MAJOR PROJECT APPLICATION MP10_0068 ENVIRONMENTAL ASSESSMENT UNDER PART 3A OF THE EPA ACT 1979

WESTFIELD PARRAMATTA DEVELOPMENT

RESPONSE TO SUBMISSIONS PUBLIC EXHIBITION OF MAJOR PROJECT 10_0068 WESTFIELD PARRAMATTA DEVELOPMENT

WESTFIELD PARRAMATTA MAJOR PROJECT MP10_0068 RESPONSE TO SUBMISSIONS

Comparative 3D Views
Proposed Office Tower Envelope &
Indicative Tower Form

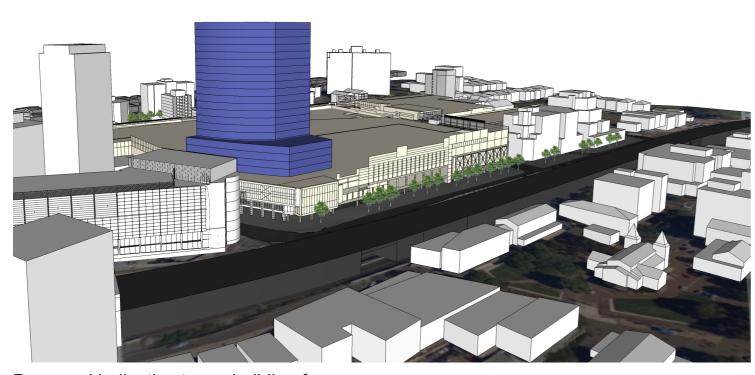
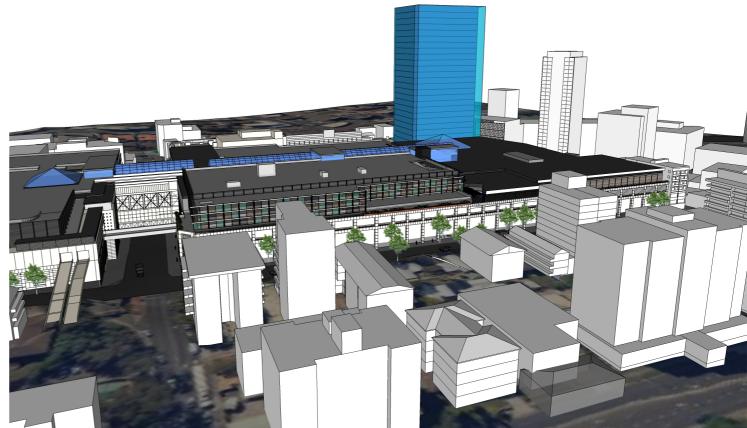
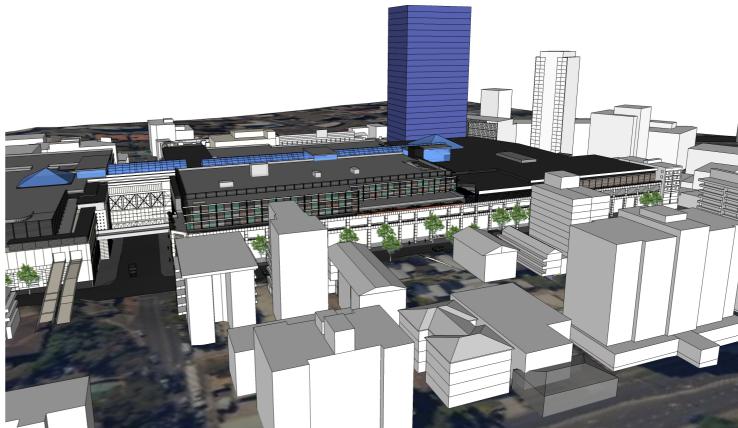
Council seeks details on proposed landscaping – soil depths, species etc.	Additional landscaping details will be included in the Stage 1 plans. Typically landscaping details would be required as a consent condition.
	Council is concerned that there is no certainty that the commercial tower will be built and prefer that it is built before the retails additions proceed. Making the commercial tower subject to a design excellence competition is strongly supported by Council. Council recommends that the Tower should be slimmer in form (maximum floor plate of 1,400m2) and placed directly on the existing retail podium, with perhaps some additional height up to 120m to compensate.	Amending the office tower form to a taller slimmer building as suggested by Council results in minimal change to the overall perceived bulk and scale of the proposed Tower form. This is illustrated in the 3D comparative views attached at Appendix A . In Appendix A at the left of each page is a diagram of the proposal as submitted, with a floor plate of approximately 1,660m2 and associated larger building envelope. At the right of each page ist he alternative reduced floor plate size of 1,400m2 and envelope area of 1,800m2. Diagram 1 shows a view looking southwest to the site. Diagram 2 shows a view looking northeast to the site. The tower building envelope as submitted occupies an area of approximately 2,000m2, which is sufficient to accommodate an office floor plate of some 1,660m2. Parramatta Council has requested

that the envelope be reduced in size to 1,800m2 and floor plate reduced to a maximum of 1,400m2. Council has indicated that it would support an increase in building height to a maximum of 120m above ground level, as compensation for reduced floor plate size.

The 3D illustrations indicate that the perceived difference in bulk and scale between the two floor plate sizes is modest at most. If anything, the slimmer, but taller option is more noticeable, due to the building encroaching further into the skyline compared to nearby residential towers in Church Street. The upper levels of the slimmer tower version will also be visible from Old Government House, whereas the tower form at the height proposed has no visual impact on the outlook from Old Government House.
